SUBJECT: Forwards marked-up responses to NRC 810909 questions re radiation protection open items. Two oversize drawings encl. Aperture cards will be available in PDR.

Subject: Palo Verde Nuclear Generating Station (PVNGS) Units 1, 2 and 3
Docket Nos. STN-50-528/529/530
File: 81-056-026, G.1.10

Reference: Letter From R. L. Tedesco to E. E. Van Brunt, Jr., Dated September 9, 1981; Subject: Comments on Responses to Radiation Protection Open Items.

PALO VERDE NUCLEAR GENERATING STATION (PVNGS)
OPERATING ORGANIZATION CHART
FIGURE 13.1-6

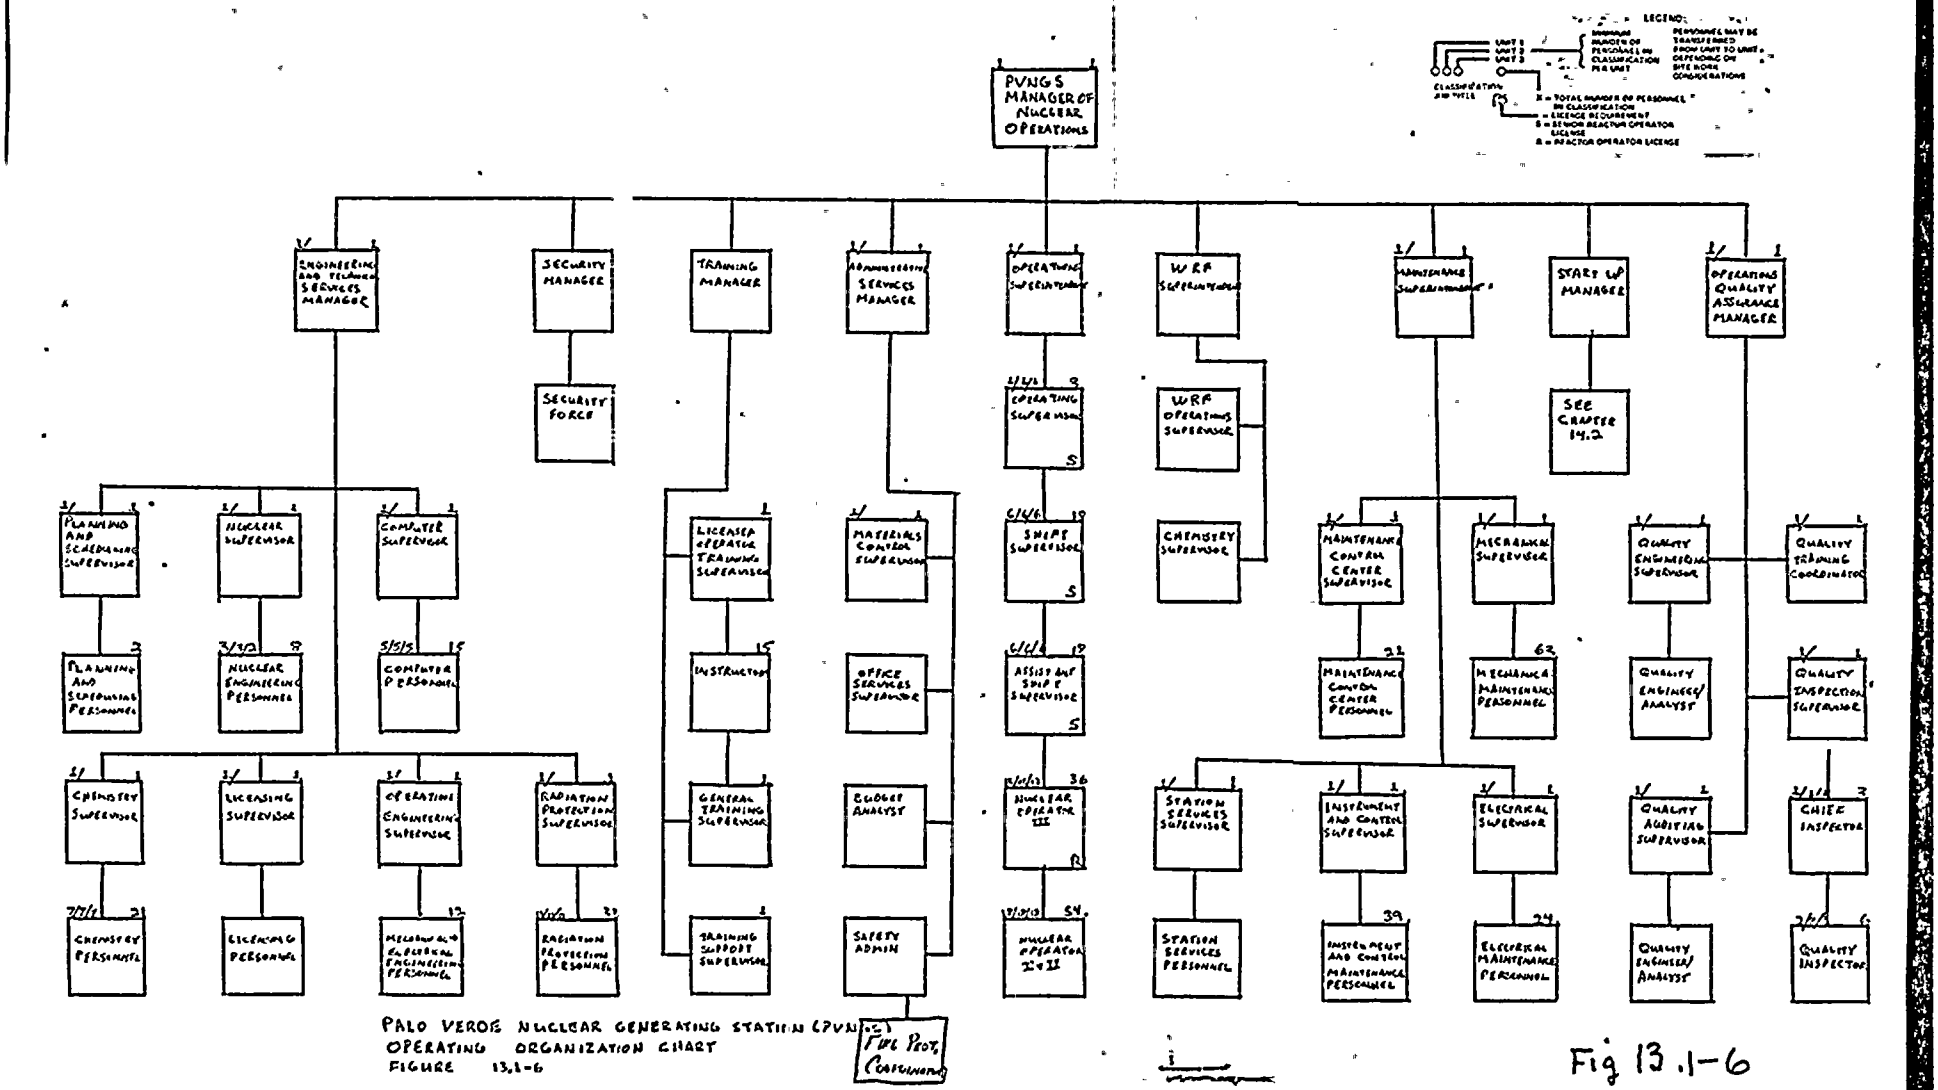
Figures 13.1-6 and 7 should be revised to show that radiation protection section is a separate organization.

See revised PVNGS FSAR figures 13.1-6 and 13.1-7, Attachment A.

DRAWING NO.	SHEET NO.	REV.	DCN NO.
13-J-ZCF-013		1	3

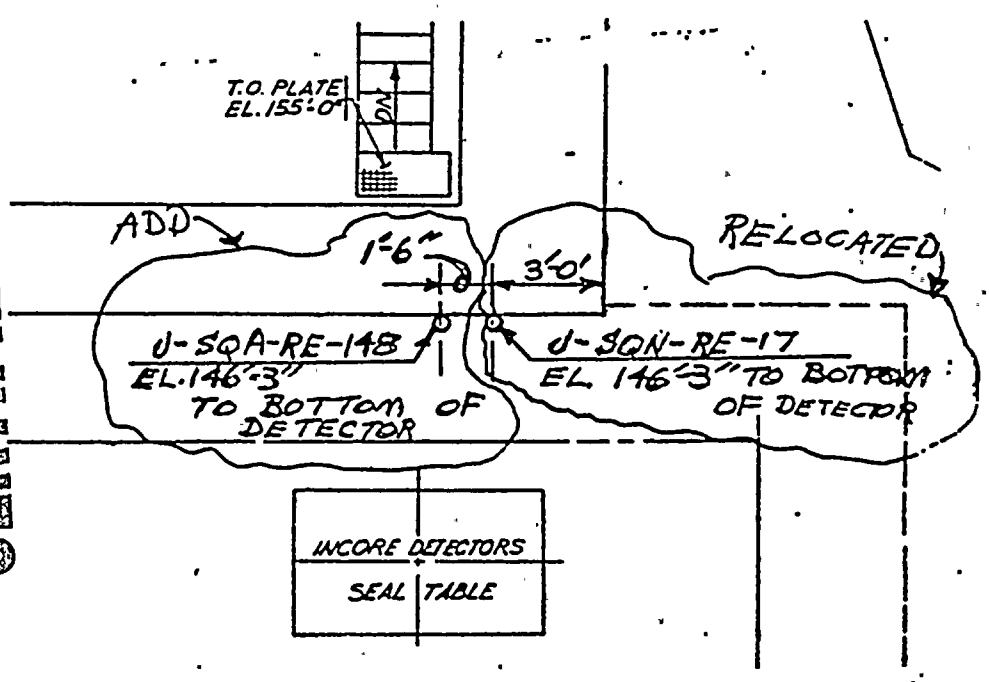
NUREG-0737, Item II.F.1.3 - The location of the containment high-range monitors should be specified.

REASON FOR CHANGE: ADDITIONAL RADIATION DETECTOR REQUIRED BY NU REG 1.97 & RELOCATED DETECTOR TO CORRECT VIEWING FIELD.

ADD RE-148 & RELOCATE RE-17 AS SHOWN.

Locations of these monitors are provided on Attachments D and E. The containment area high range monitors are numbered RE148 and RE149.

DCN NUMBER			
DRAWING NO.	SHEET NO.	REV.	DCN NO.
13-J-ZCF-014		0	2

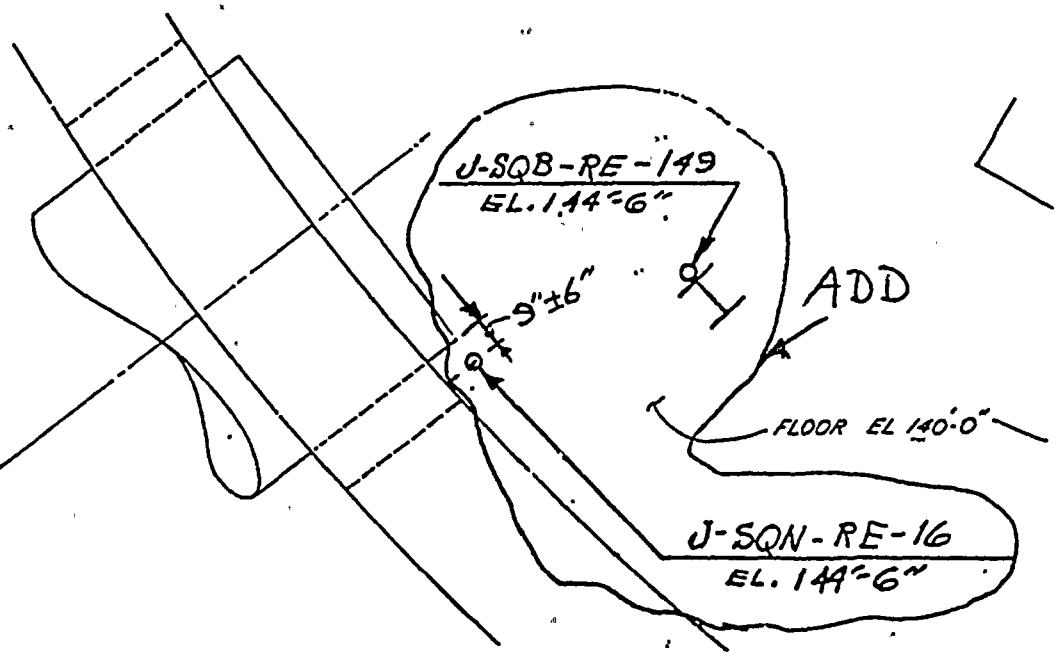
ADD RE-16 (EXISTING) & RE-149 AS SHOWN
